Gachsaran Polymer Industries Company HDPE Plant		
	LCP and Junction Box Layout, Arrangement and Wiring Drawing for Refrigerator Package		 
PO No.: GPIC-PT-MA-PO-000-3029	Document Number: VD-GPIC-MA-3029-3029-0046	Rev. 00	Page 1 of 14

LCP and Junction Box Layout, Arrangement and Wiring Drawing for Refrigerator Package

LCP-6101A

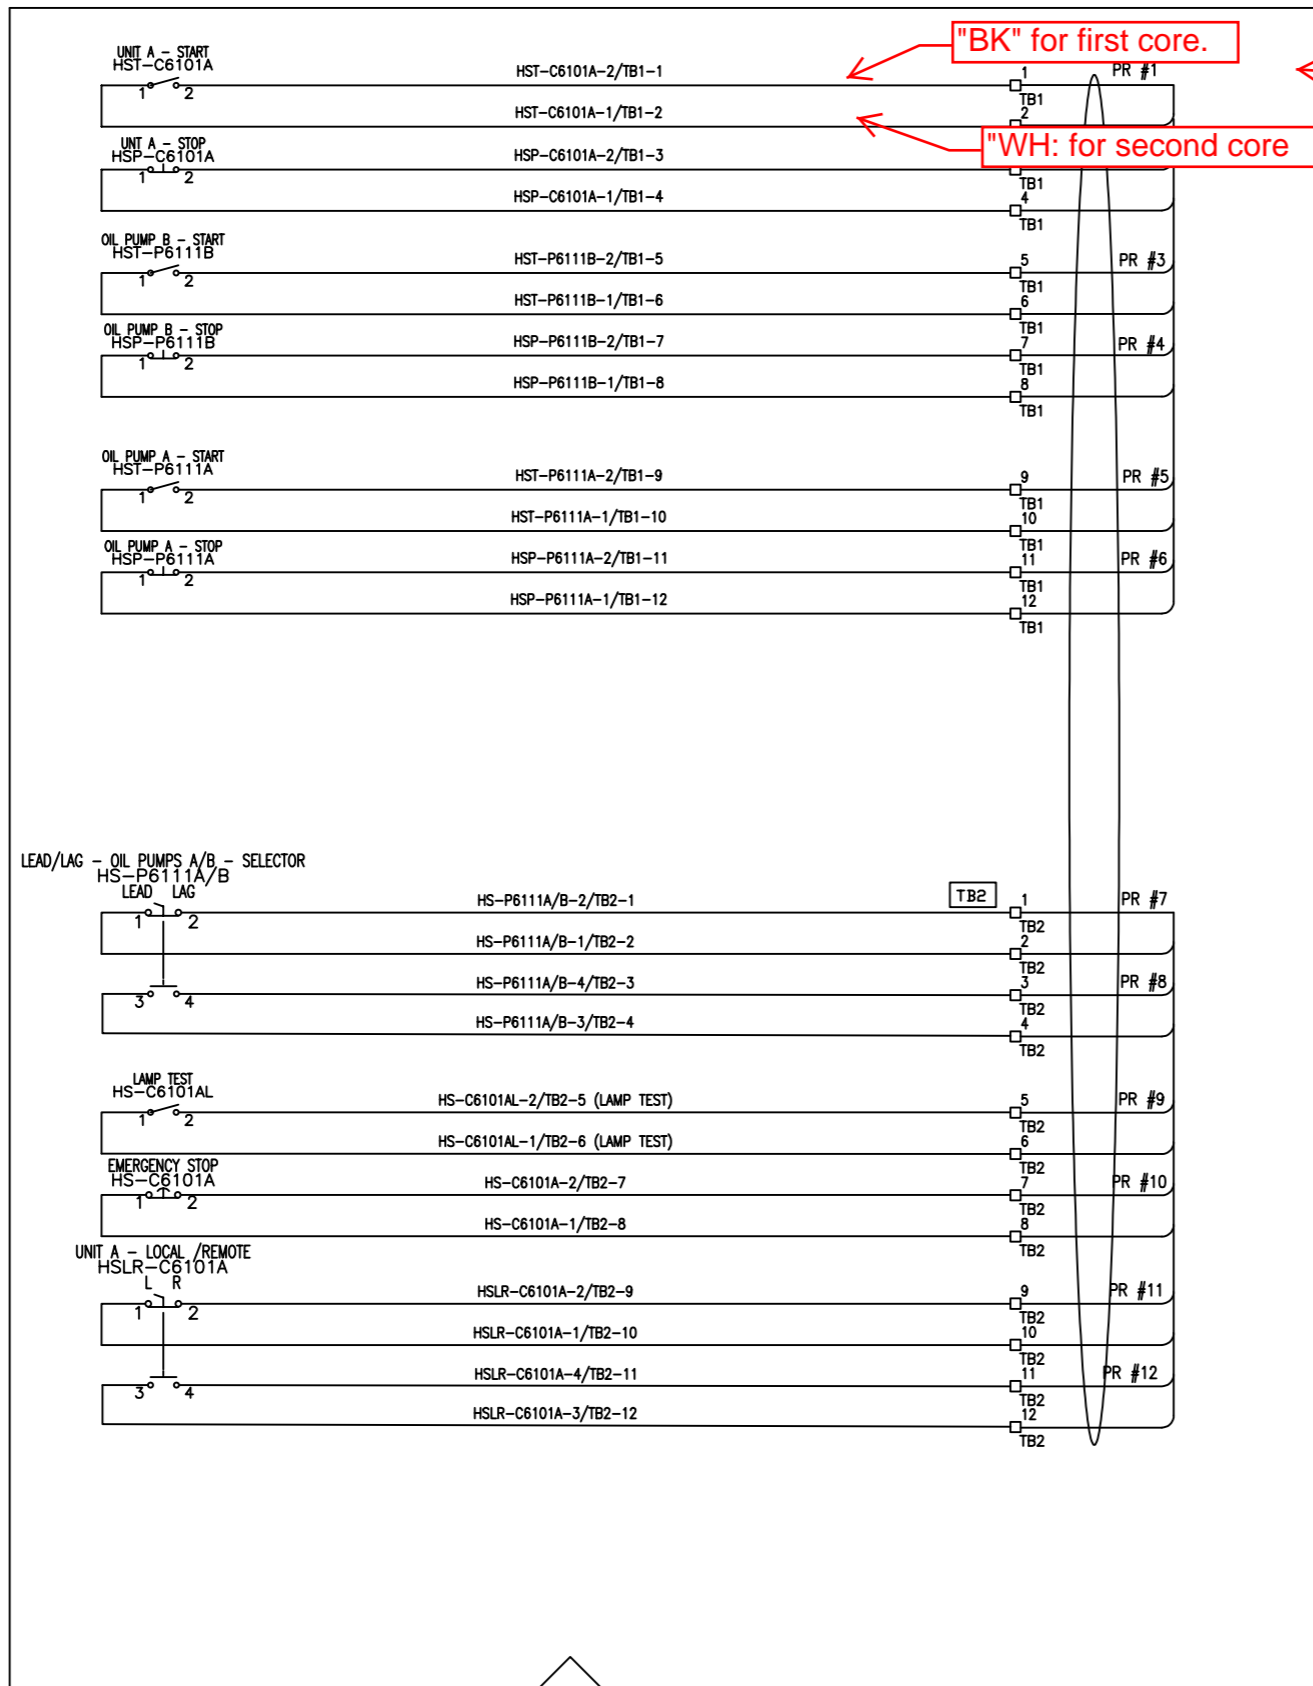
This comment shall be implemented for all items in all sheets.

EL01:
 - Bearing and winding RTD signals shall be shown.
 - It is possible to connect winding RTD to MCC but it would be better to connect directly to vendor UCP. The vendor should make a decision based on their experience and warranty and reflect this in the I/O list and wiring.

EL02:
 Vendor shall clarify if there is an ammeter on the LCP. If there is an analog ammeter, it is possible to send a current signal from the MCC. If a 4-20 mA signal is required, the Vendor shall route this signal to the UCP.

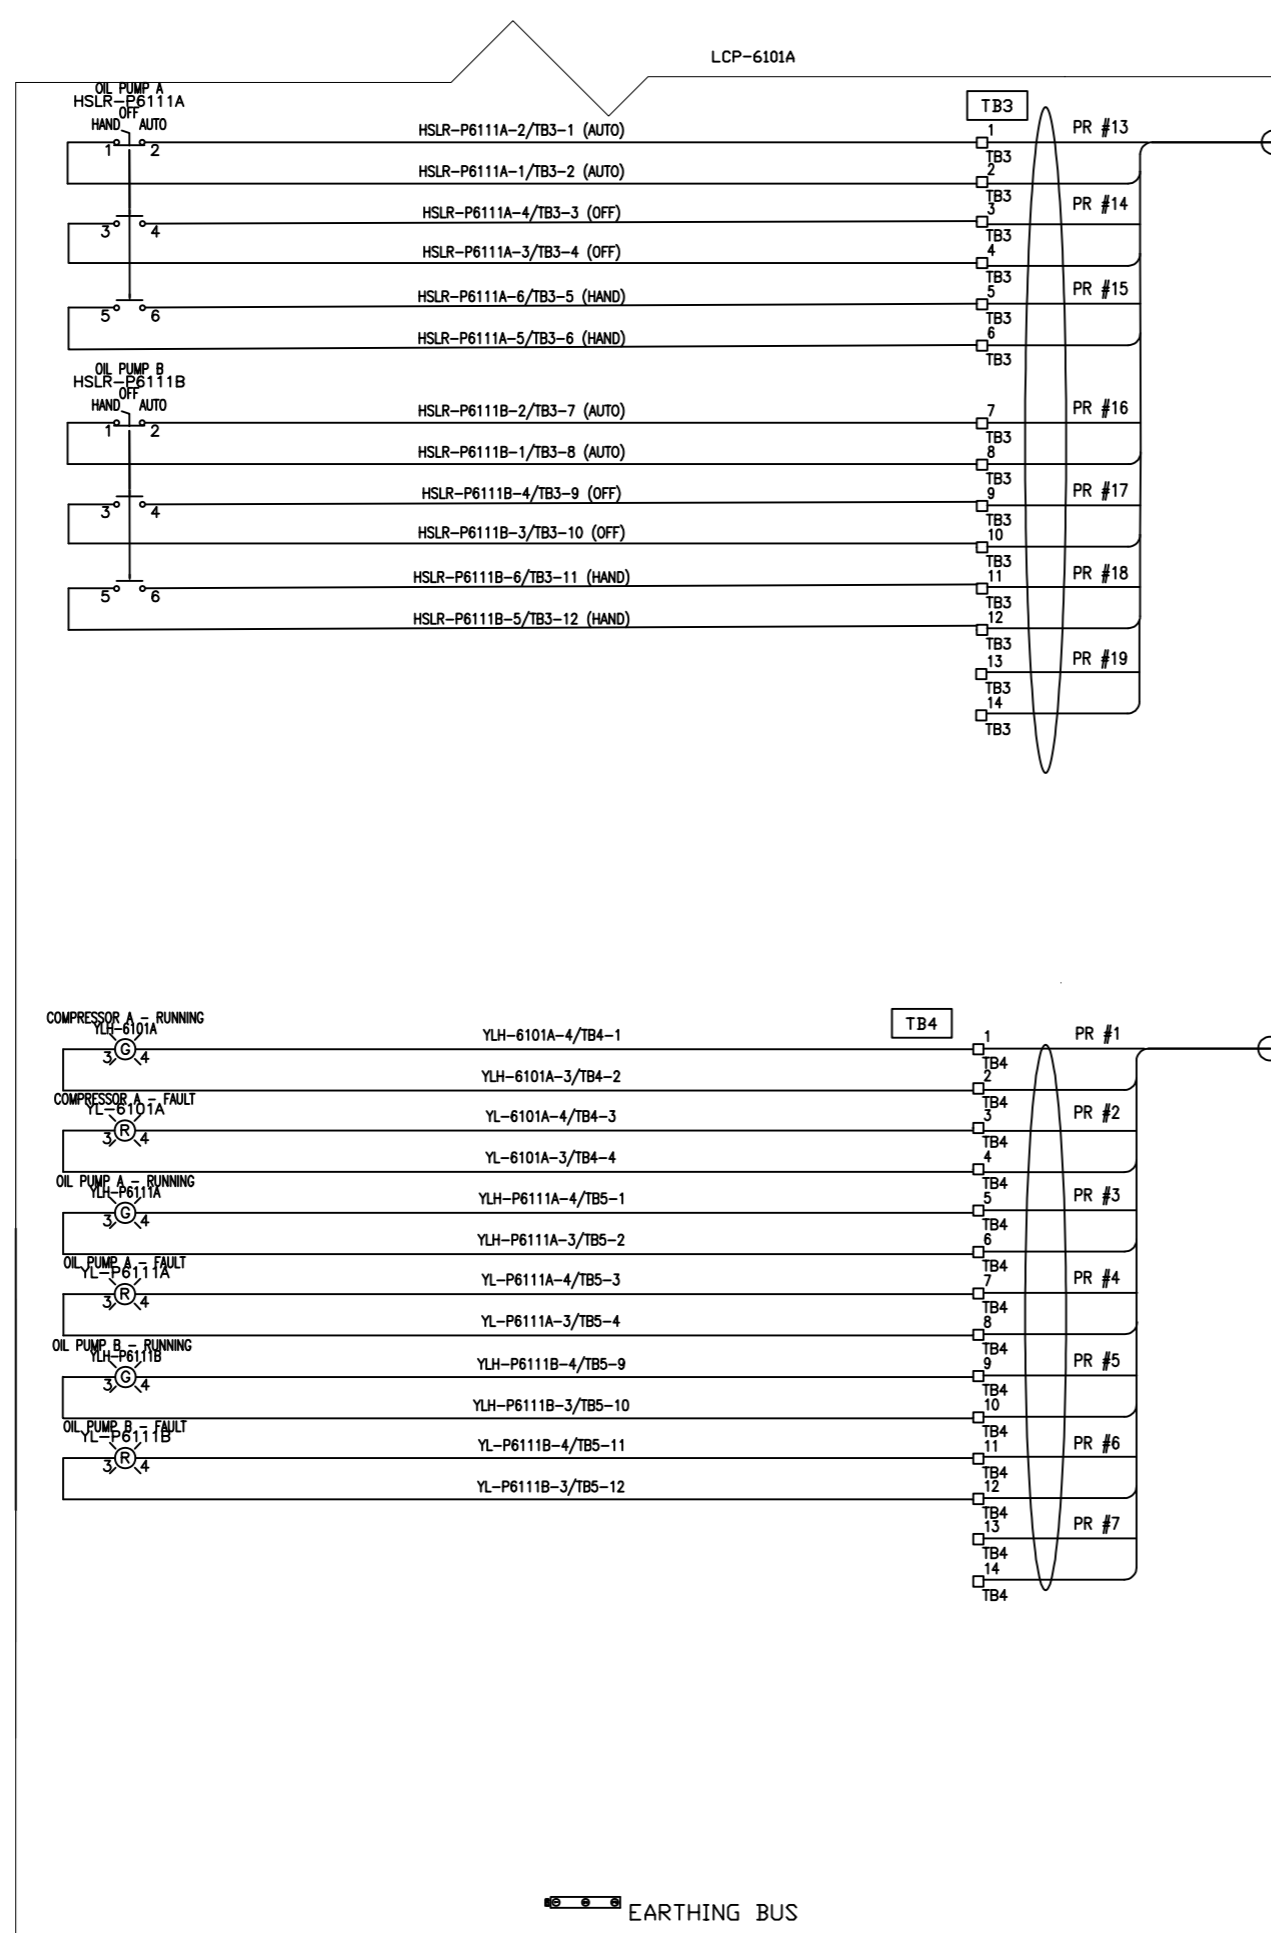
Delete it.

Add cable tag: UCP-LCP-6101A-1

All cable glands on LCP and JBs shall be supplied by Vendor.

Delete it.

Add cable tag: UCP-LCP-6101A-2

FRT-19Px1mm² OSCR/SWA/NIS/GRAY (300/500)

FRT-07Px2.5mm² SWA/NIS/GRAY(300/500)

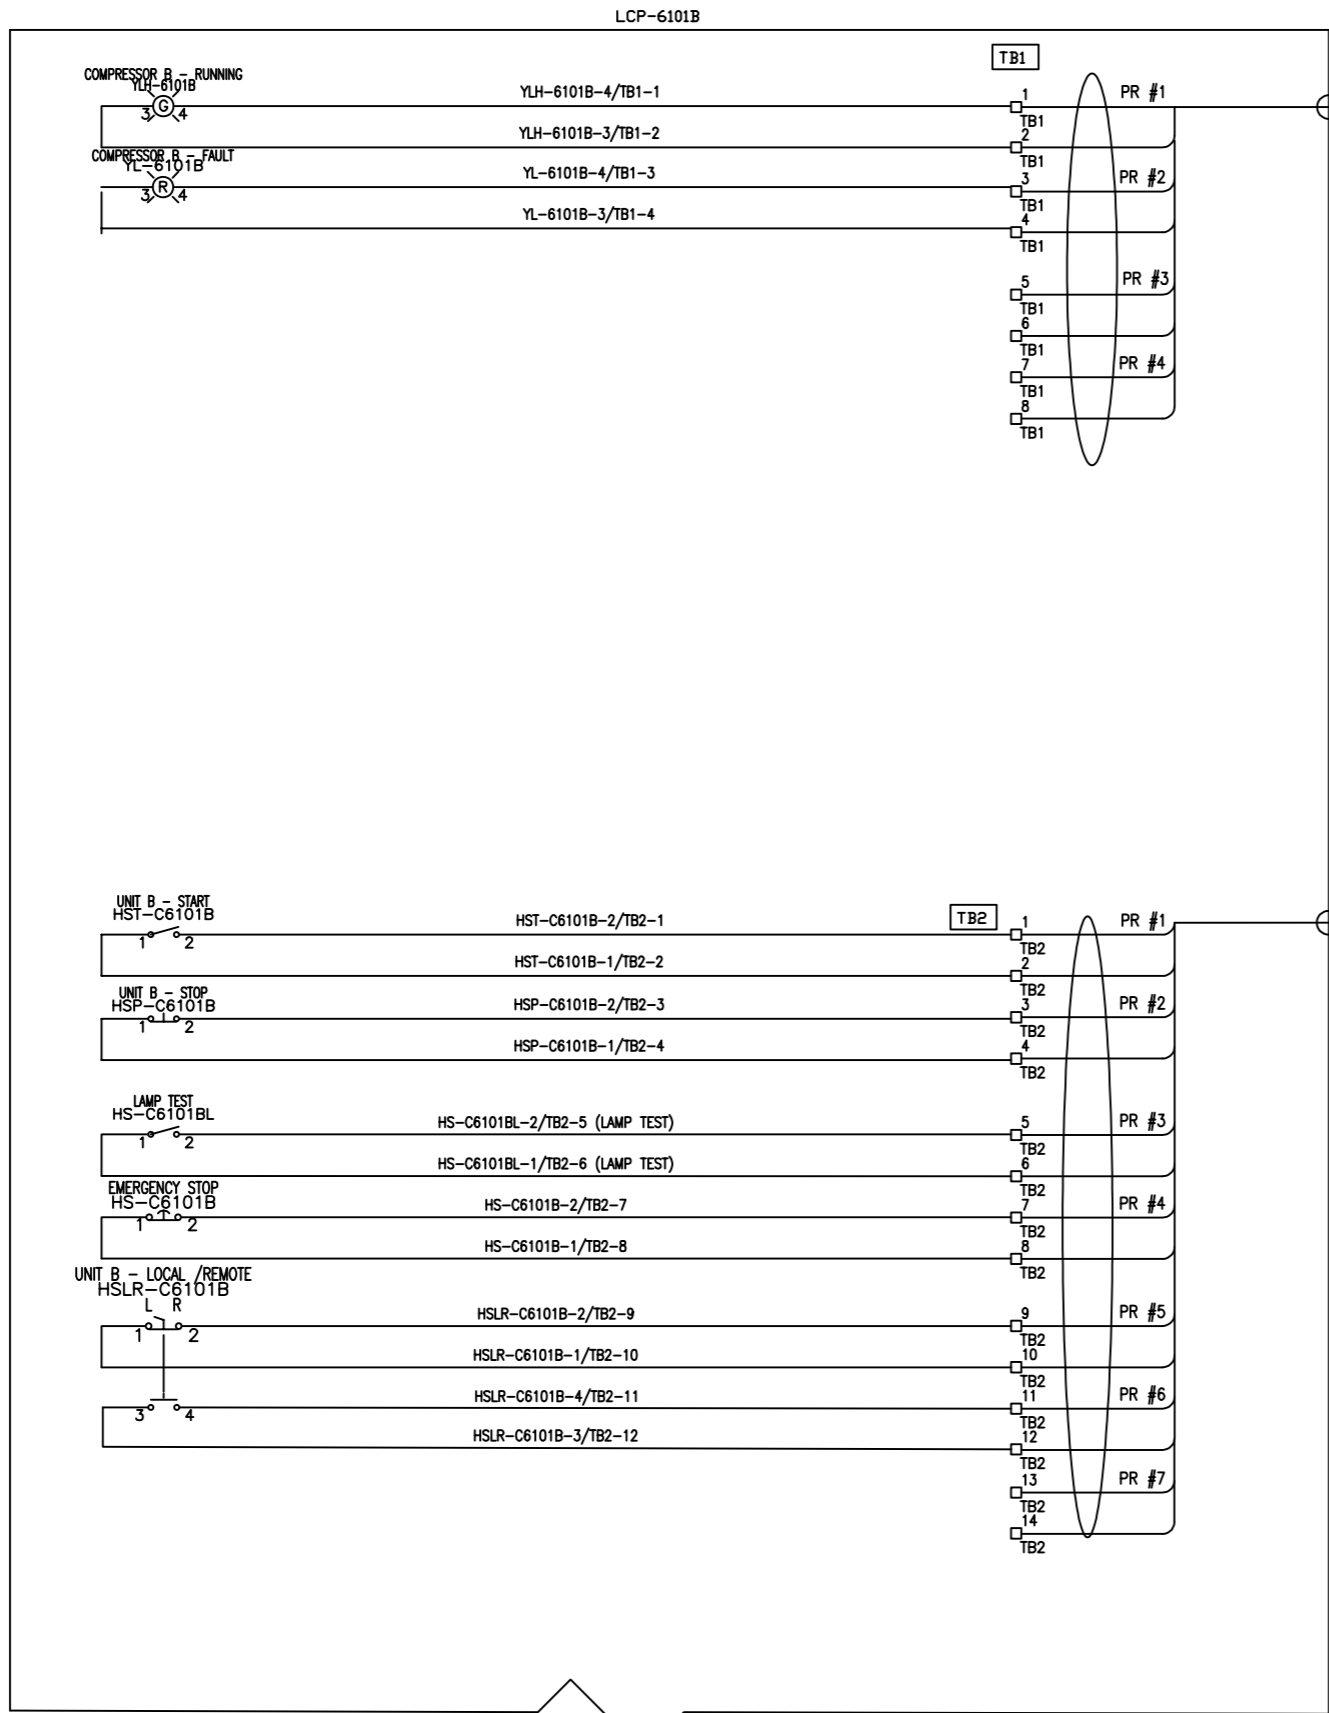
DELETE IT.

ADD CABLE TAG: UCP-LCP-6101B-2

DELETE IT.

ADD CABLE TAG: UCP-LCP-6101B-1

FRT-04Px2.5mm² SWA/NIS/GRAY(300/500)

FRT-07Px1mm² SWA/NIS/GRAY(300/500)

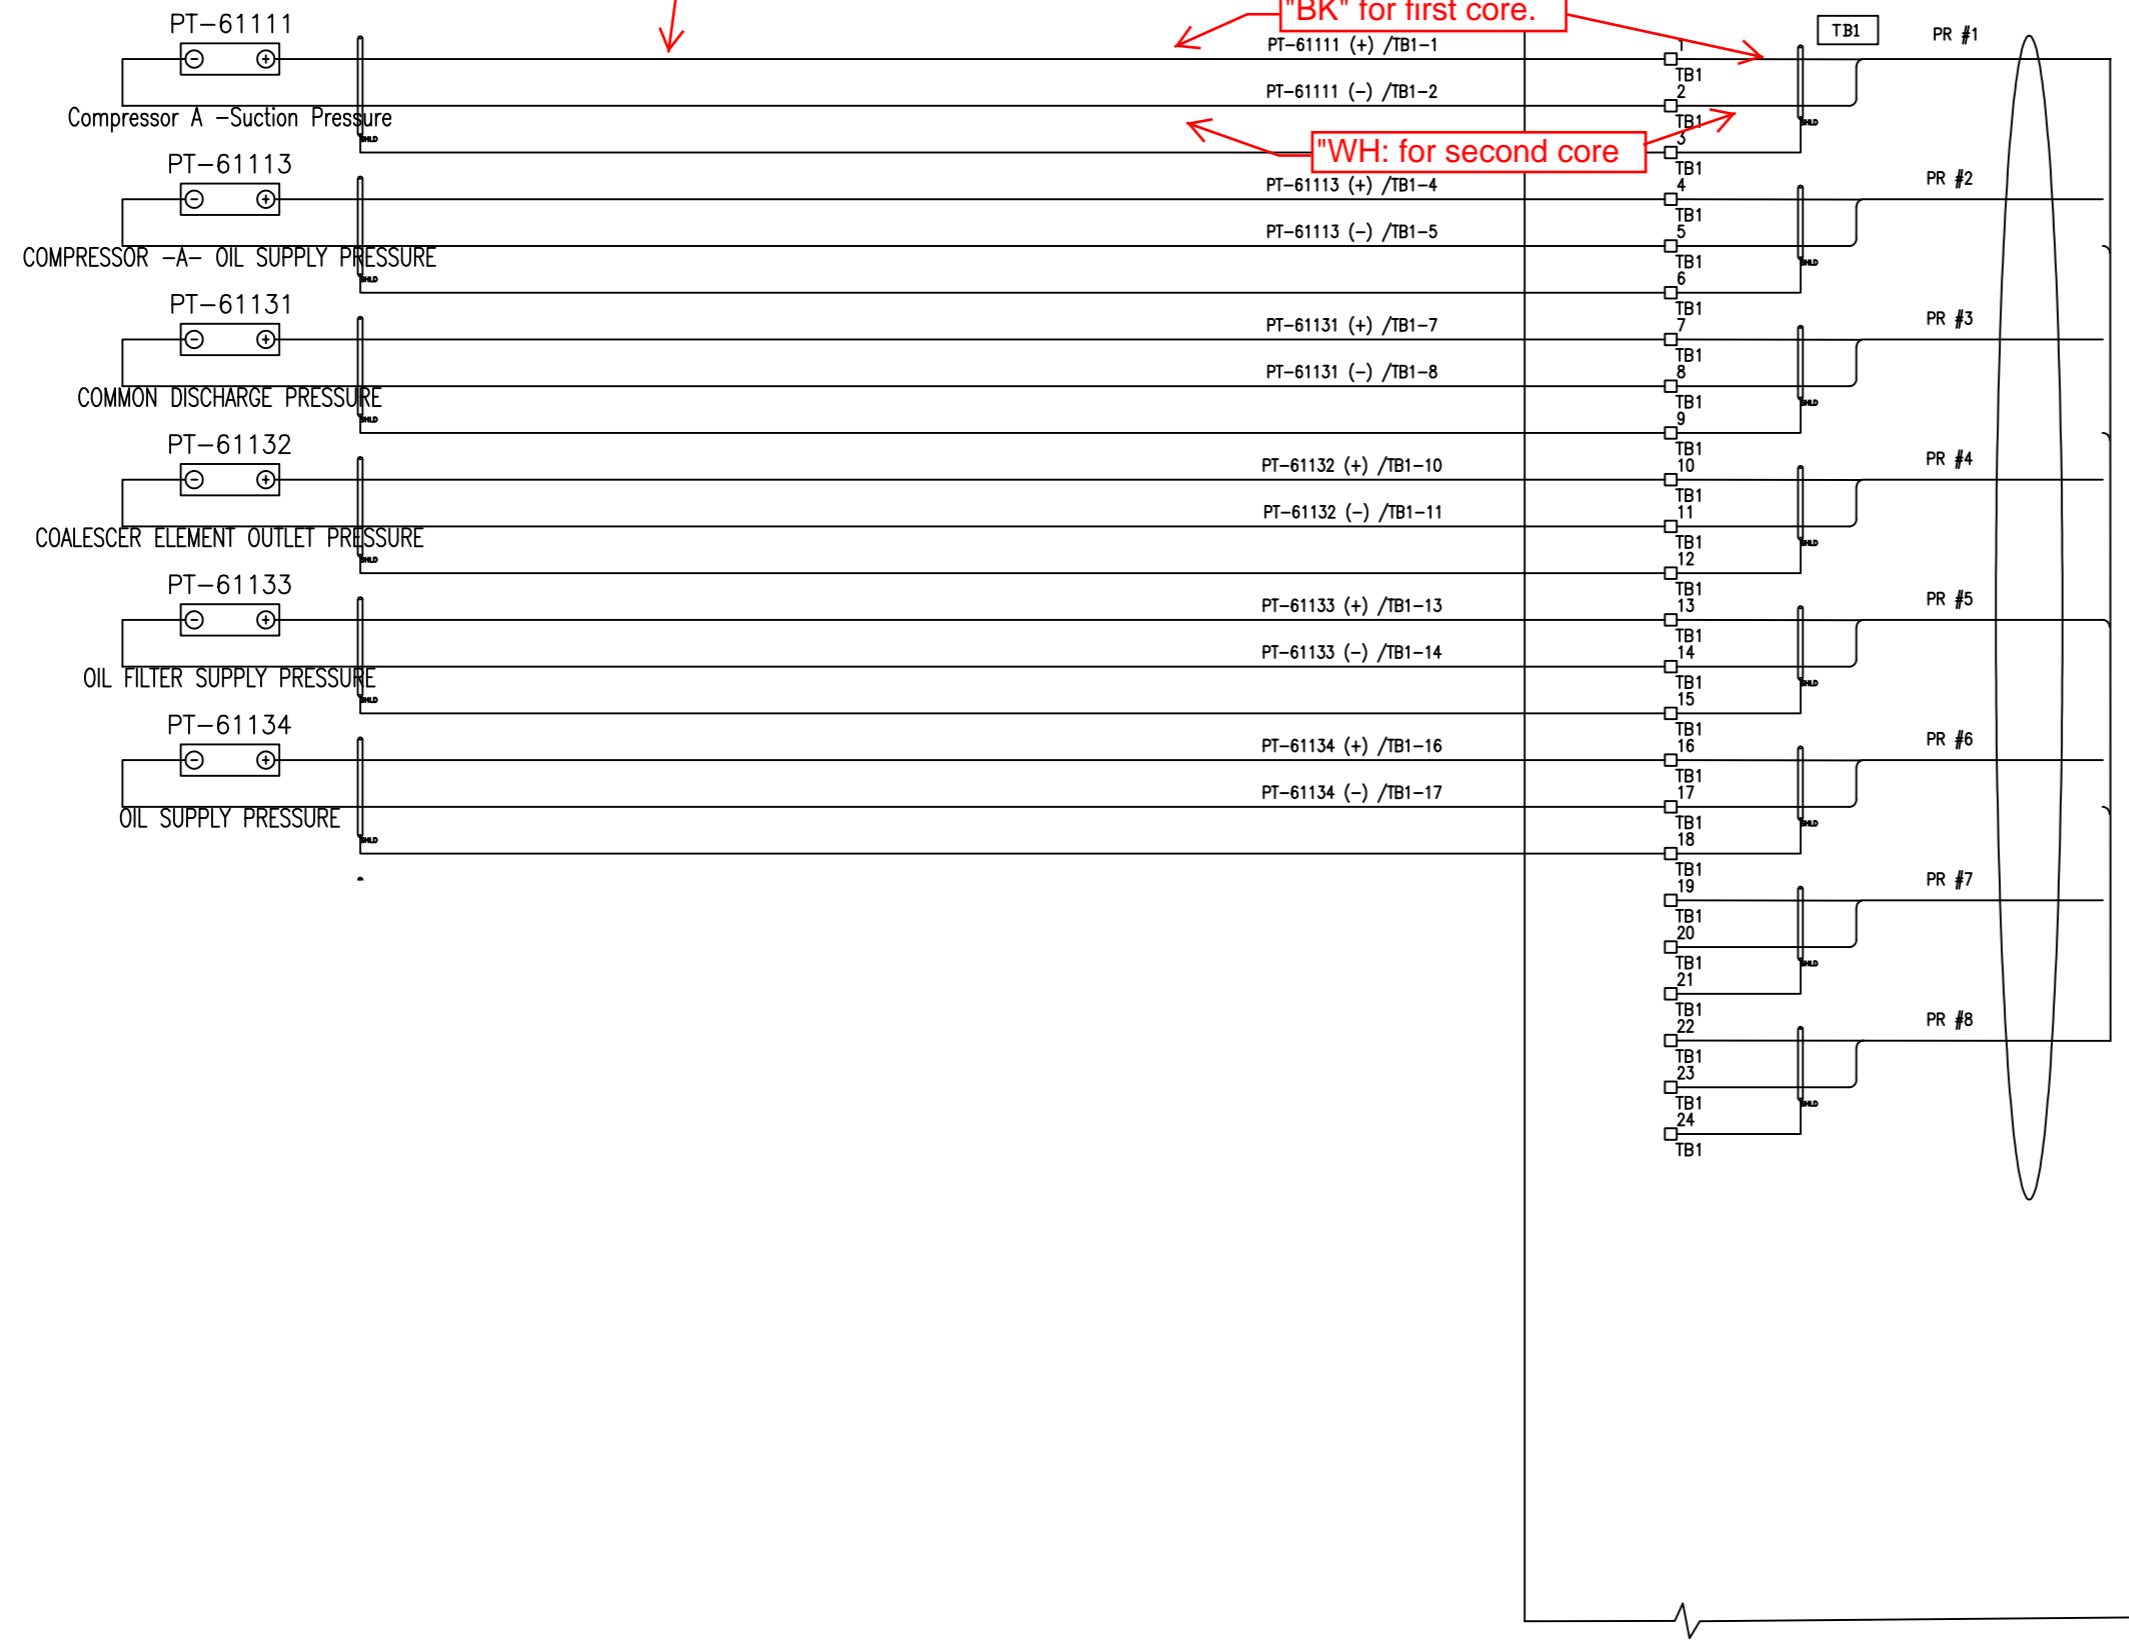
"FRT-01Px1.5mm² OSCR/SWA/IS/BLUE (300/500)"
for all single pair cables.

This comment shall be implemented
for all items in all sheets.

"BK" for first core.

"WH: for second core"
